5.3 Responses to Submissions

The Submission Analysis Register located in **Appendix A1** details where issues raised in submissions were required by the Coordinator-General to be responded to in the AEIS. Instances where a direct response to a submission item was requested for the AEIS, the appropriate reference has been provided in the column titled “Relevant AEIS Reference”.

Figure 5.3-A PM₁₀ concentrations recorded at Balgowan (µg/m³) and adopted background concentration

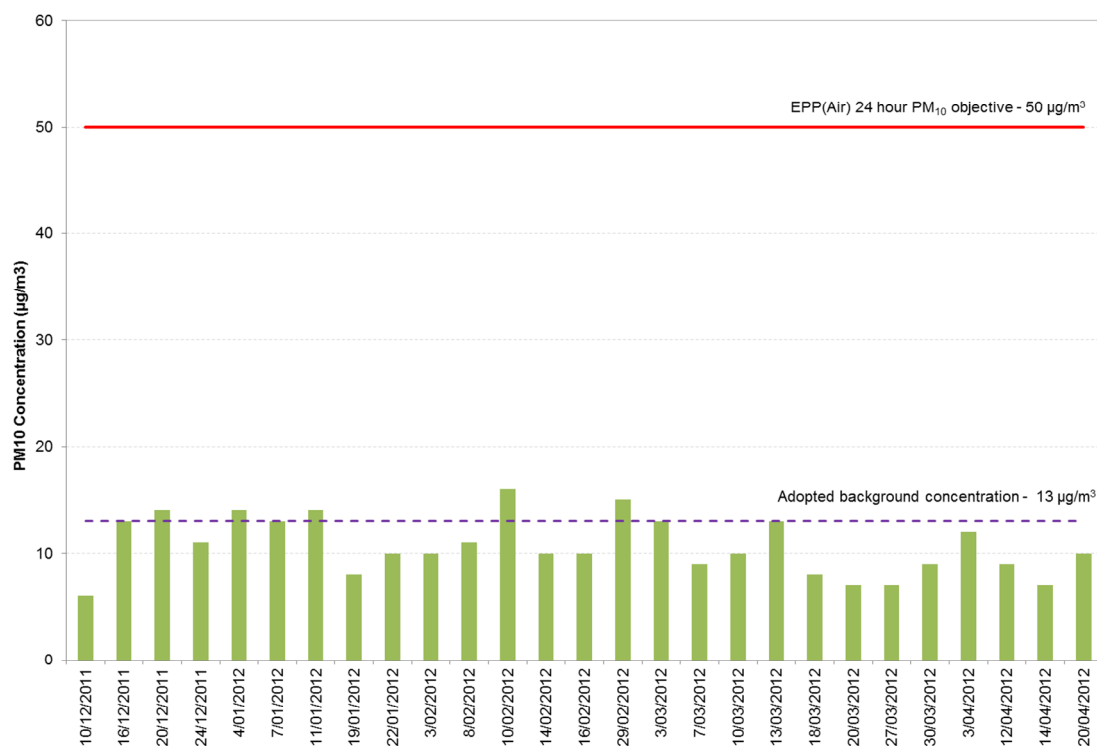
The 2011/2012 period contained the most amount of air quality monitoring data to undertake a validation study. NAC conducted a monitoring campaign measuring PM₁₀ at Balgowan located approximately 2 km northwest of the Mine. For the purposes of the validation study presented in **Appendix G.6.6** of the draft EIS, a 70th percentile 24 hour average PM₁₀ from the Balgowan data (13 µg/m³) presented has been adopted as the background concentration. EPA Victoria (2007) recommends adopting the 70th percentile pollutant concentration to determine cumulative impacts.

The PM₁₀ concentrations recorded at Balgowan are presented in **Figure 5.3-A**. The adopted background concentration for the validation study is also presented in **Figure 5.3-A**. Dust monitoring results recorded at Balgowan in 2011/2012 are consistent with long term particulate monitoring results undertaken by NAC. The adopted background PM₁₀ concentration of 13 µg/m³ is considered appropriate to determine potential cumulative impacts of current mining operations.

Figure 5.3-B Ideal size distribution of particle mass

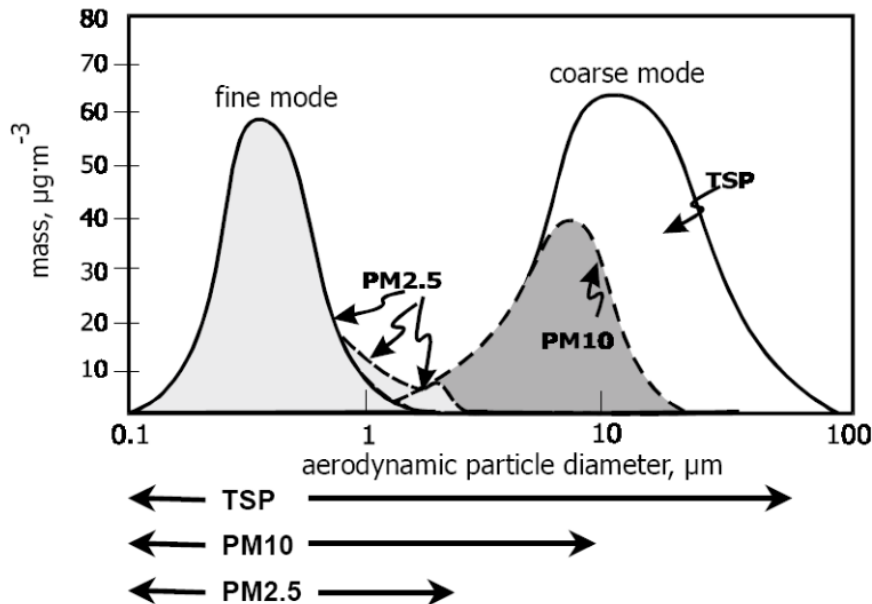
- particles with an equivalent aerodynamic diameter greater than 10 µm;
- particles with an equivalent aerodynamic diameter between 2.5 and 10 µm; and
- particles with an equivalent aerodynamic diameter less than 2.5 µm.

An ideal size distribution of airborne particulates by mass is presented in **Figure 5.3-B**. The coarse particles are produced through mechanical processes with potential sources including wind-blown dust and mining operations. Particulates generated from mining operations of the revised Project are predominantly coarse.
